**CITY OF BOULDER
PLANNING BOARD MEETING AGENDA**

AGENDA TITLE: Concept Plan Review and Comment Request for a proposed redevelopment of 7 lots totaling 2.94 acres at 2955, 2969, and 2995 Baseline Road and 735-775 30th Street. All existing buildings are proposed to be demolished and two (2) 4-5 story multifamily student housing buildings with a total of 100 units are proposed. The proposal would include rezoning the properties at 765 and 775 30th Street from RM-2 to RH-5. Reviewed under case no. LUR2025-00012.

Project Name: HUB BASELINE
Location: 2955, 2969, and 2995 Baseline Road and 735-775 30th Street
Size of Property: Approx. 2.94 acres (128,066 square feet)
Zoning: Residential – Medium 2 (RM-2), Residential – High 5 (RH-5), and
Business – Transition 1 (BT-1)
Comprehensive Plan: High Density Residential (HR) and Transitional Business (TB)

Figure 4: BVCP Land Use Designations

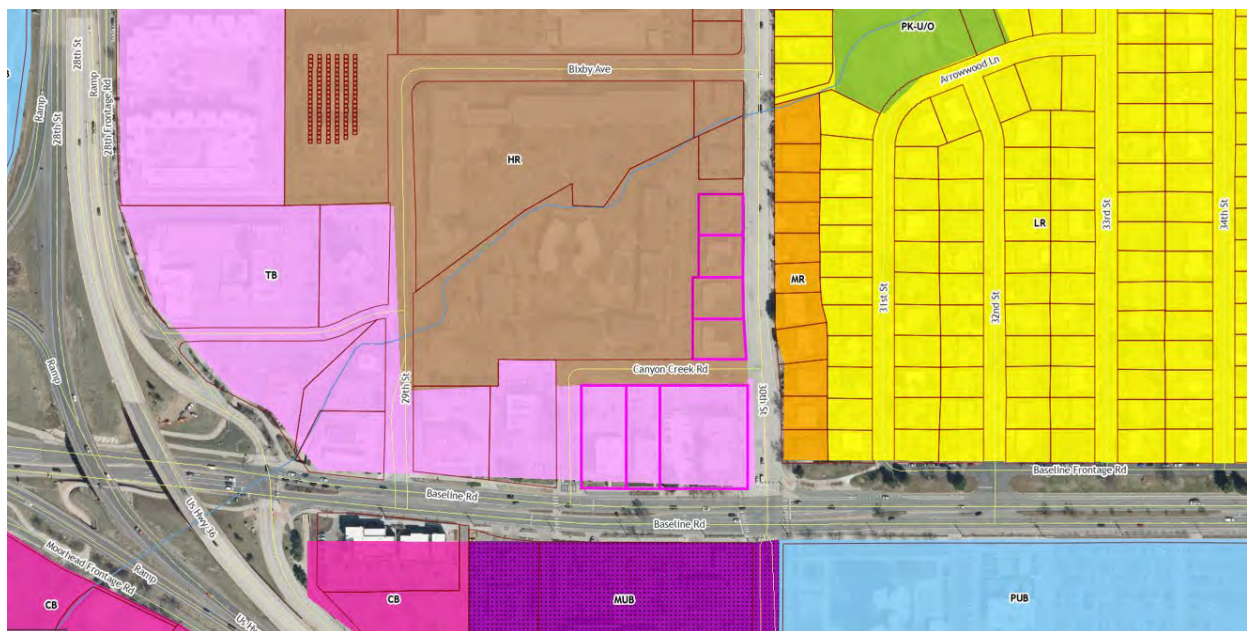
As shown earlier in **Figure 4**, the BVCP designates the northern portion of the property as “High Density Residential” which are areas “generally located close to the University of Colorado, in areas planned for transit-oriented redevelopment and near major corridors and services.” Residential uses such as attached dwelling units are permitted by-right in the existing and proposed residential zoning districts in this area of the site.

In terms of conformity of the proposed development with the Boulder Valley Comprehensive Plan land use designations, staff finds that the project site is an appropriate location for student housing near the university and multi-modal corridors, but encourages the applicant to reconsider the residential-only nature of the proposal in the Transitional Business area.

Figure 5: Zoning Districts

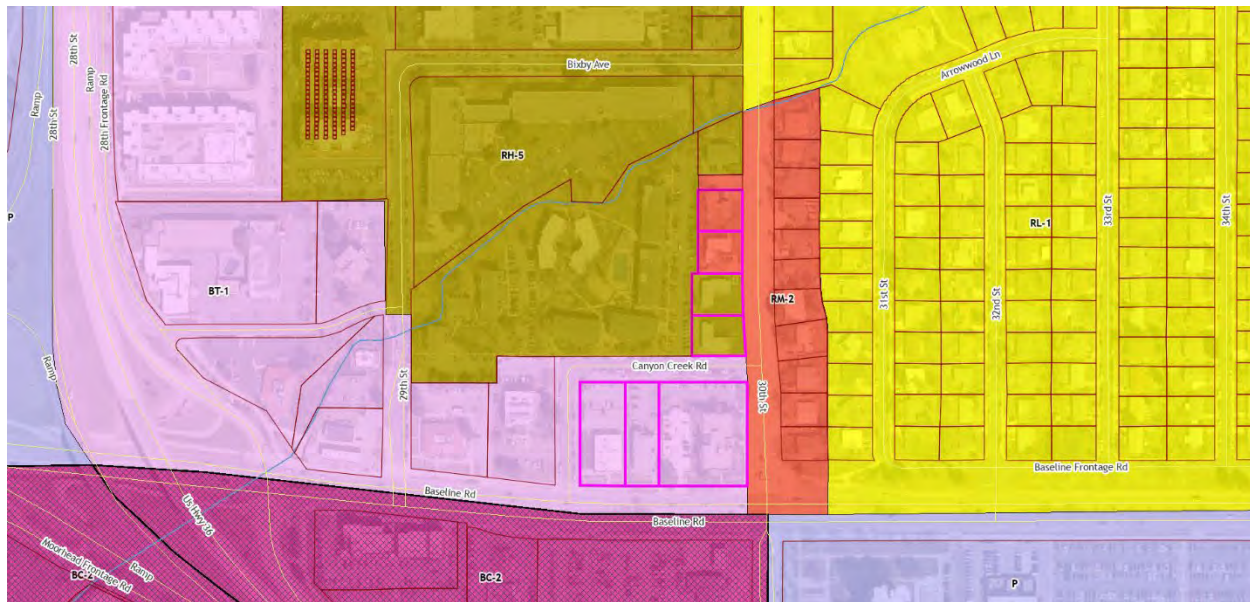
The proposal includes a rezoning request for a portion of the property along 30th Street to change from Residential-Medium 2 (RM-2) to Residential-High 5 (RH-5).

Based on the zone district purposes described in Section 9-5-2(c), B.R.C. 1981, the proposed zoning change would be consistent with underlying BVCP land use designation of High Density Residential in this location, and is consistent with the rezoning criterion 9-2-19(e)(1) that the proposed rezoning is necessary to come into compliance with the Boulder Valley Comprehensive Plan map. The area directly adjacent to the site is similarly designated High Density Residential land use in the BVCP and zoned Residential High-5, which further supports the compatibility of this change with the adjacent areas.

CONCEPT PLAN REVIEW 03.04.2025
SITE PLAN - OVERALL 0-A 0.1

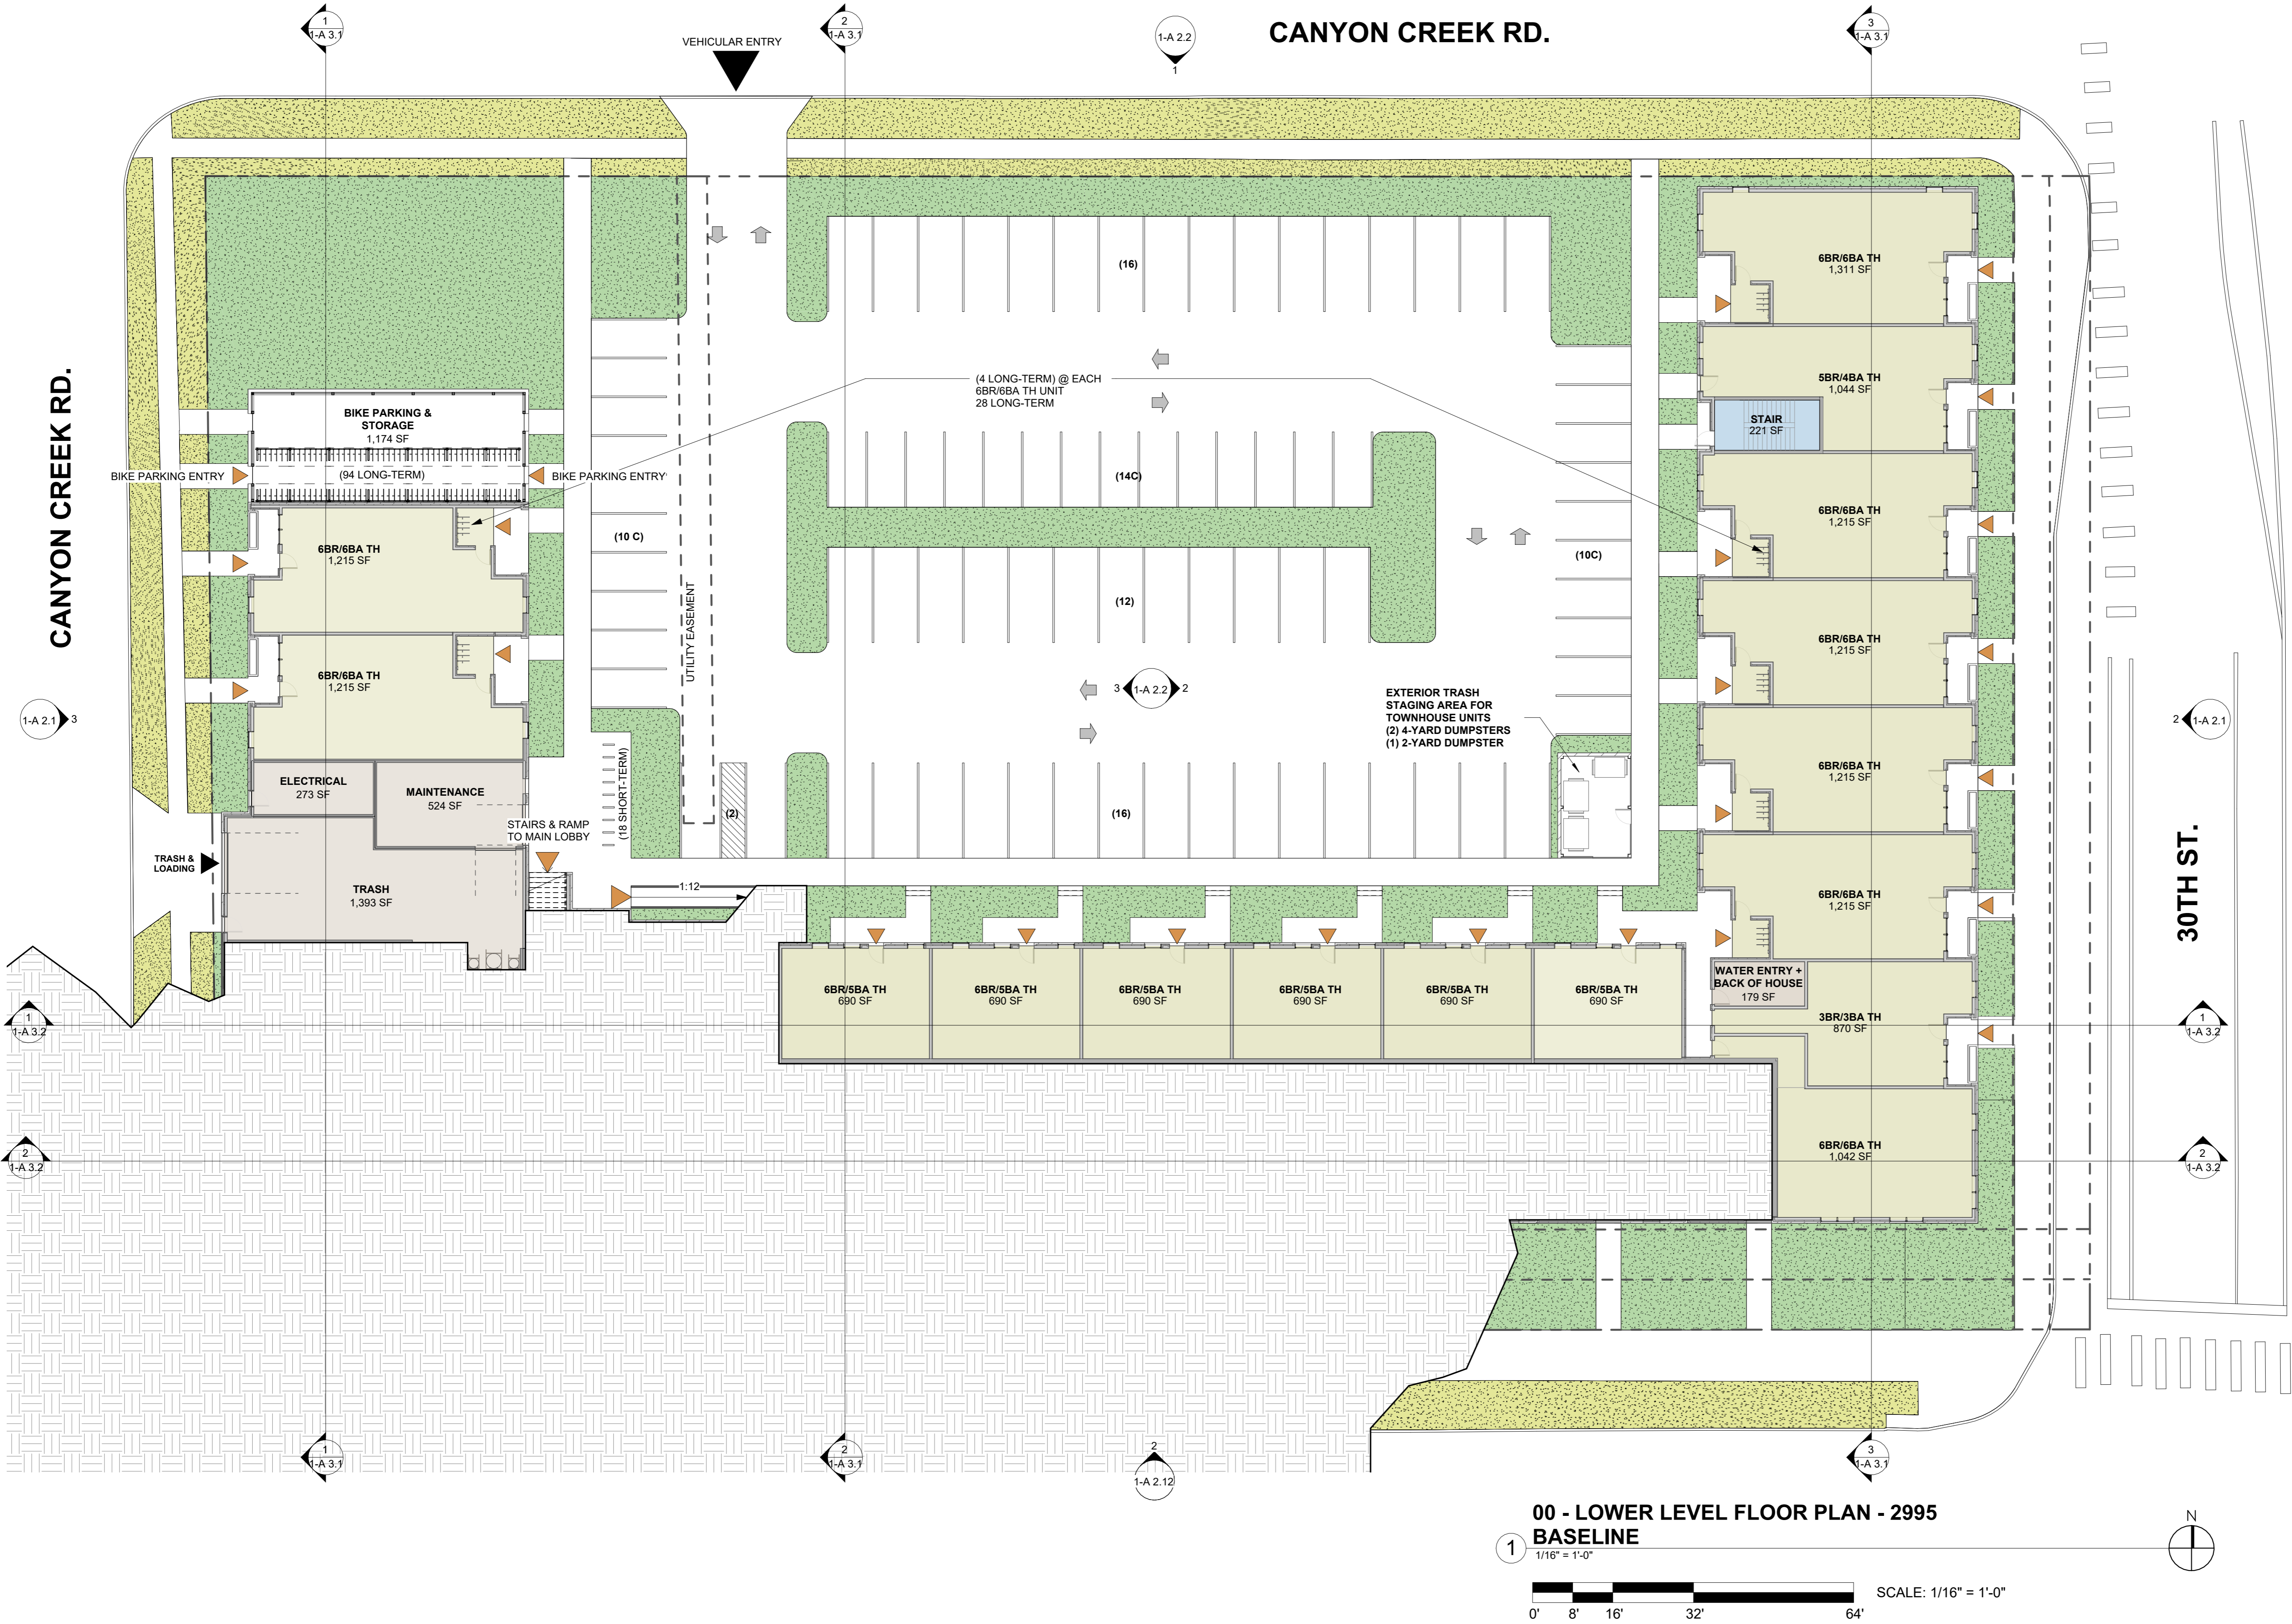
- o. Sheet 0-A0.1 identifies that 2 accessible parking stalls are being provided out of 80 total stalls. Per Table 208.2 of the 2010 ADA Standards for Accessible Design, 4 accessible parking stalls are required to be provided. Please revise the plans as necessary prior to site review application.
